RE: Cross Gold Mine, Permit No. M-1977-410, Technical Revision No. 10 (TR-10), Adequacy Review No. 2

The Division of Reclamation, Mining and Safety (DRMS) has completed its review of your adequacy response submitted on April 20, 2022 for Technical Revision No. 10 (TR-10). After reviewing the materials submitted, DRMS has identified the following adequacy item(s) that must be addressed before an approval of TR-10 can be issued:

EXHIBIT E - CROSS AND CARIBOU MINES MINING PLAN MAP: CROSS MINE AND CARIBOU MINE				4 REVISION
Project:	CROSS AND CARIBOU MINE - AM 2 APPLICATION	Project No.:	21-1306	MAP 02
Location:	NETHERLAND, COLORADO, USA	Date:	FEB. 2022

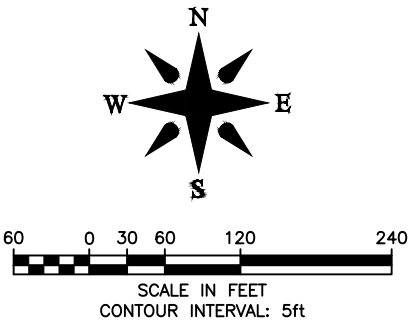
- 1) DRMS has the following comments pertaining to Figure 1 – Water Management System:
 - a. The pipelines shown are said to be “bonded under AM2”. This is not entirely accurate. Please review the enclosed Exhibit E – Mining Plan Map approved in AM-2. Note there are some differences between the pipelines approved in AM-2 and the ones shown on this figure. While current plans may not involve the regular use of certain pipeline segments (e.g., pipeline from Pond 3c to Pond 2, pipeline from Pond 1 to Pond 2), if these pipelines will remain in place and potentially be used as overflow pipes, etc., then they should be included on this figure, and differentiated accordingly (e.g., as emergency overflow pipelines).
